Addendum

Amended Statement of Environmental Effects

DA 498/2017– “Whitton Place” proposed Mixed Use Development at 87-99 Oxford Street and 16-22 Spring Street, Bondi Junction.

BTG Planning
June 2018

Figure 2– Above, Level 1 plan as lodged and below as amended

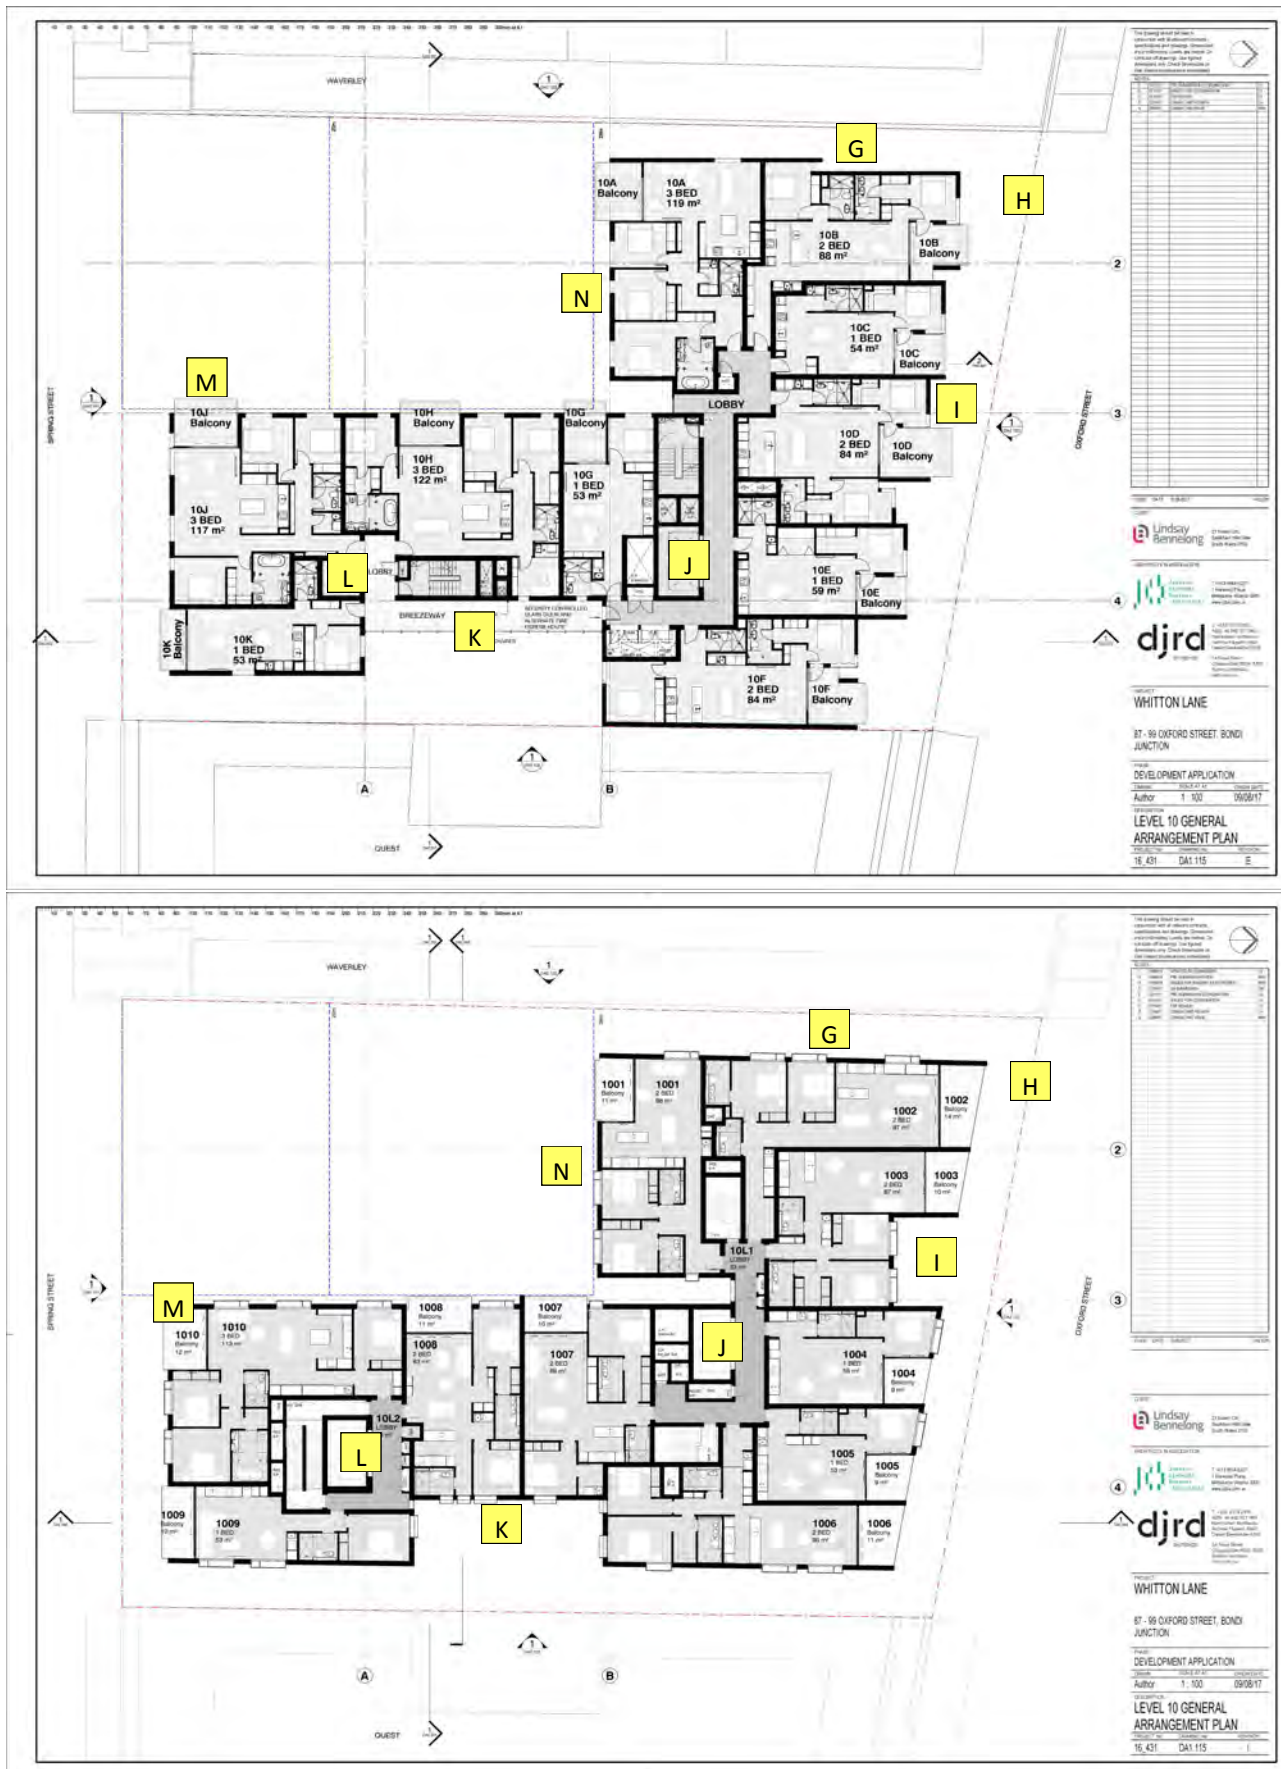
- Rationalisation of the arcade floor levels;
- Deletion of the “breezeway” access on the eastern elevation and replanning of lift access;
- Removal of the swimming pool and egress at Level 1 and replacement with commercial space;
- Addition of a street awning to the Spring Street podium;
- General replanning of units where necessary.

A	Public arcade rationalised to accord with changes to tenancies and floor levels made to comply with disability access requirements between Oxford and Spring Streets.
B	Lobby and pedestrian access to Oxford Street for main tower building enlarged and improved.
C	Lobby to Spring Street residential podium changed to directly connect to Spring Street and made larger. Retail 1 enlarged.
D	Lobby to main tower from Spring Street altered to accommodate twin lifts.
E	Delete gymnasium and open pool deck to Level 1 and replaced with commercial space
F	Amalgamation of commercial space Level 1
G	Western side set back to West Elevation has been increased to 3m minimum
H	Facade to Oxford Street has been made parallel to the Street.
I	A large central recess added to visually break the length of the facade.
J	Position of main tower lobby and lifts altered and design improved.
K	Southern set back increased to a minimum of 3 m and the breezeway access removed.

L	Improved twin lift lobby to replace breezeway access design.
M	Rear balcony facing Spring Street changed.
N	Minor change to depth of Arcade
O	South facade apartments 1201 & 1301 reconfigured to avoid shadow effects.
P	Elevation to Oxford Street altered to accord with revised unit configurations and made more simple.
Q	Ground and level 1 elevation to Oxford St implies 6m wide bays and introduces planting
R	New Eastern side set backs, material and fenestration changes to suit internal planning
S	New Western side set backs, material and fenestration changes to suit internal planning
T	Elevations to Spring Street altered to accord with revised unit configurations and made more simple.
U	Addition of awning to Spring Street frontage
